Standardized Nuclear Unit
Power Plant System

February 1, 1985
SLNRC 85-5 FILE: 0543
SUBJ: Wolf Creek Technical
Specifications

Docket No. STN 50-482

FIGURE 3.2-3

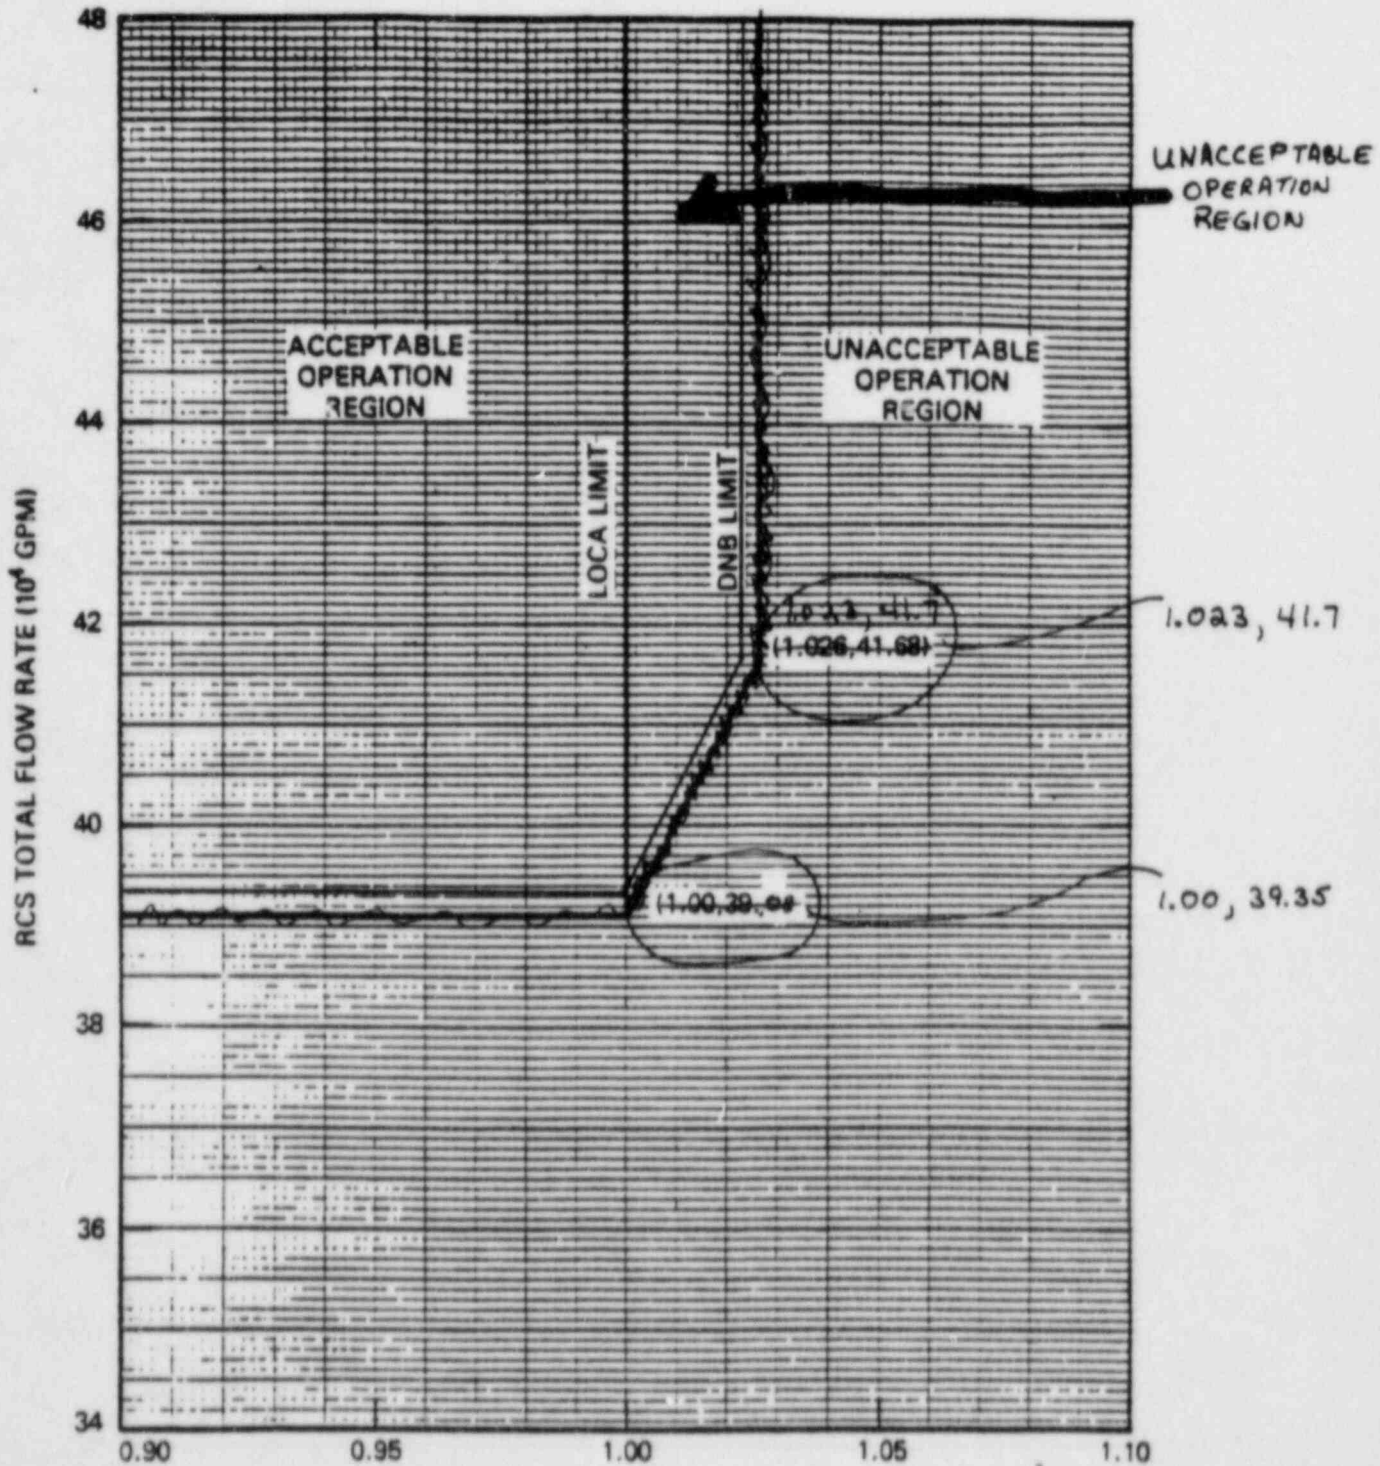
c. $F_{\Delta H}^N$ = Measured values of $F_{\Delta H}^N$ obtained by using the movable incore detectors to obtain a power distribution map. The measured values of $F_{\Delta H}^N$ shall be used to calculate R since Figure 3.2-3 includes measurement uncertainties of ~~2.1%~~ 2.8% for flow and 4% for incore measurement of $F_{\Delta H}^N$.

MEASUREMENT UNCERTAINTIES OF ²⁸2.4% FOR FLOW AND 4.0% FOR INCORE MEASUREMENT OF $F_{\Delta H}^N$ ARE INCLUDED IN THIS FIGURE
